At the October 6, 2022 hearing for Zoning Case 22-06, the DC Zoning Commission granted party status to the Capitol Square HOA (CS-HOA), an incorporated association representing 93 individual townhomes and HOA-owned and maintained community property and roads located within 200 feet of the proposed development at 899 Maine Ave SW (originally referred to as 801 Maine Ave. in the zoning case).

In the hearing, the Zoning Commission tasked the Applicant, Jair Lynch, to meet again with the Capitol Square HOA, and submit a report to record detailing the outcomes of the meeting by 3PM ET, November 21, 2022.

Attachment 1 – Cut Through Traffic Map vs. Applicant Site Plan

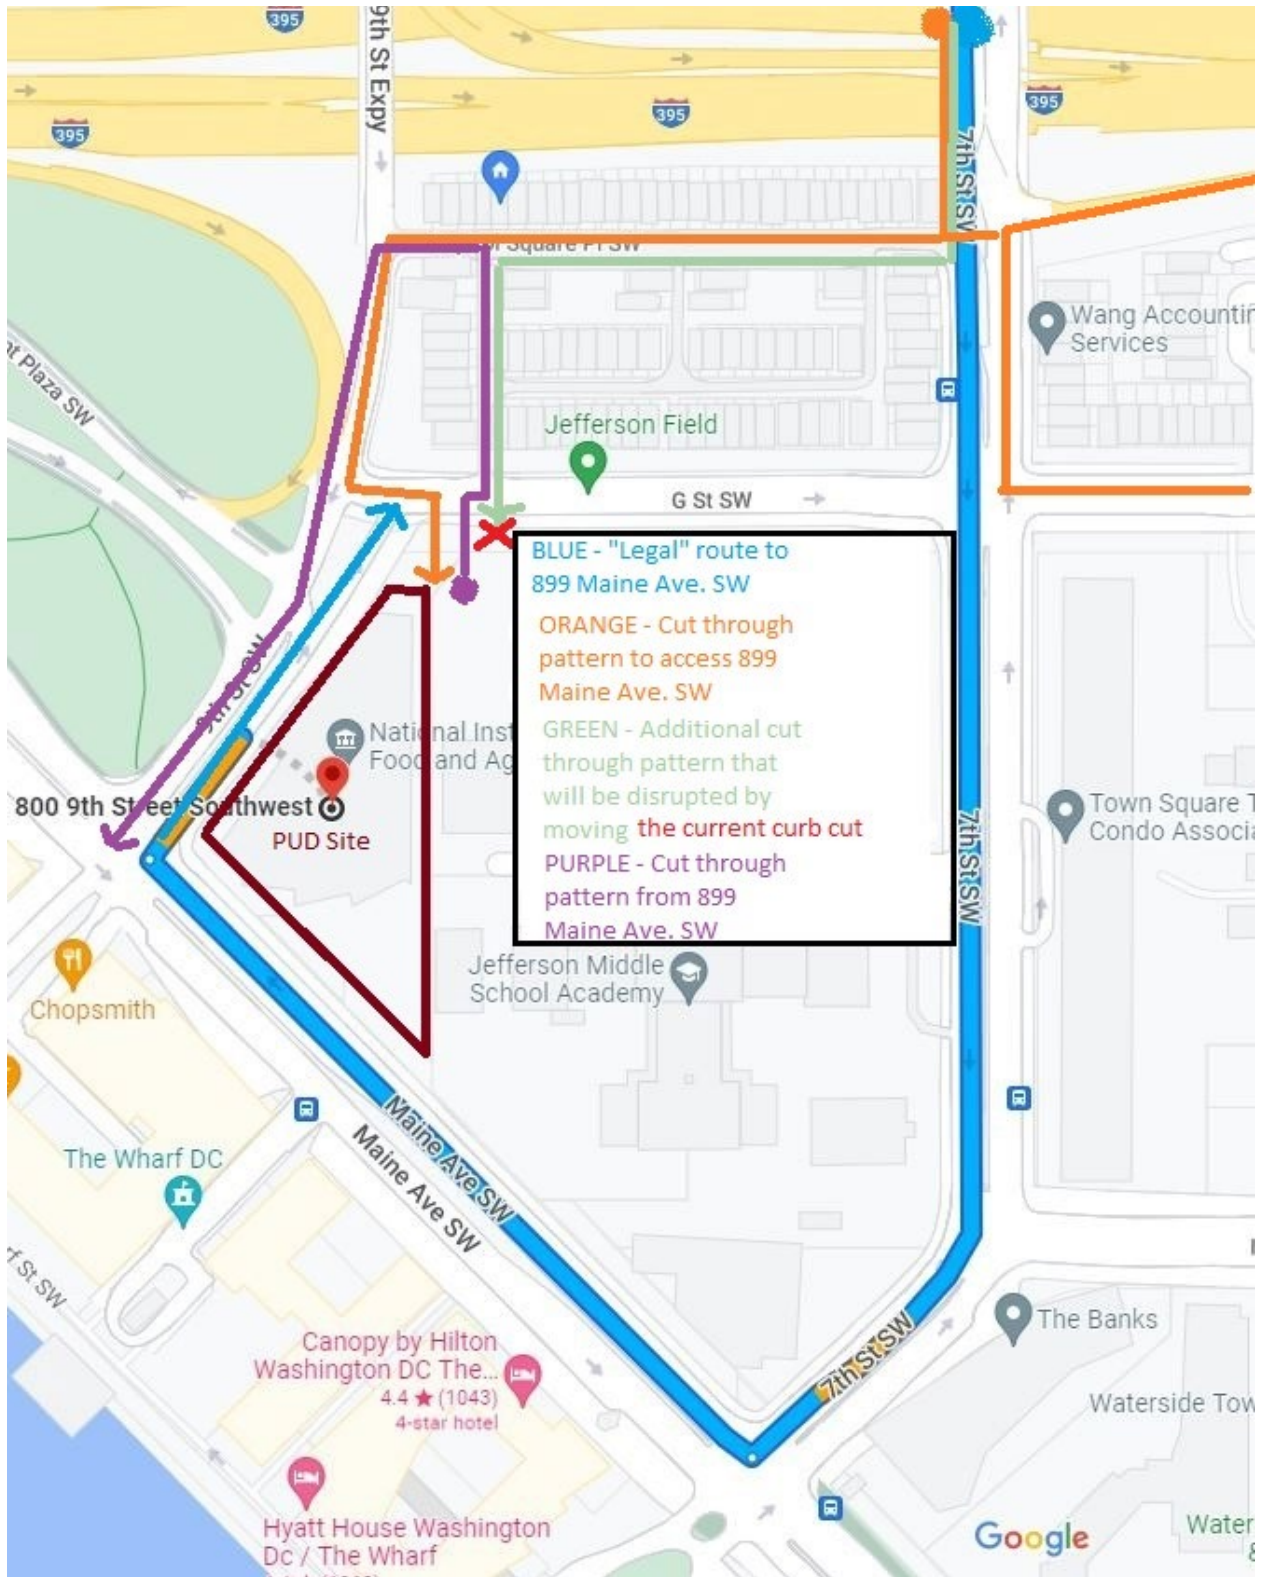
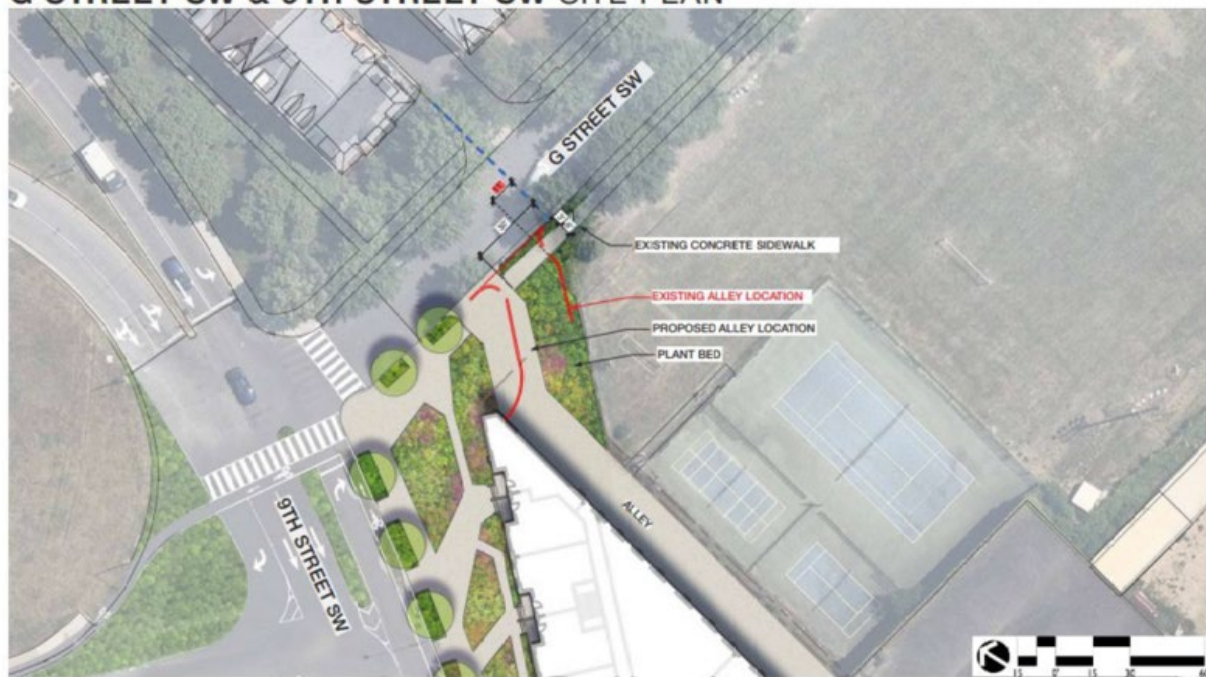
The Applicant also repeatedly stressed what they consider adequate mitigation in the form of the move of their G Street curb cut to the west (See Attachment 1 the “green pattern”). We do appreciate that work, but unfortunately since we did not have any data during the discussion, it was not clear that the cut-through traffic wouldn’t instead just use our 9th Street curb cut, make a couple of left turns, and then a quick right to access 899 Maine’s parking garage (See Attachment 1 the “orange pattern”). Furthermore, it does not prevent cars leaving 899 Maine intending to access Maine Ave to the west from exiting right out of that moved curb cut, proceeding to immediately turn left into our G Street curb cut, then speeding north on our alley to turn left and exit the community via our 9th Street curb cut, which would let them head south on 9th to more quickly head west on Maine (See Attachment 1 – the “purple pattern”).

Below shows the relocation of the curb cut (from the Applicant's presentation) that we are happy about as it prevents a direct cut across from our G Street curb cut shown in the light green pattern; however, it would mostly just force drivers to use the orange pattern instead
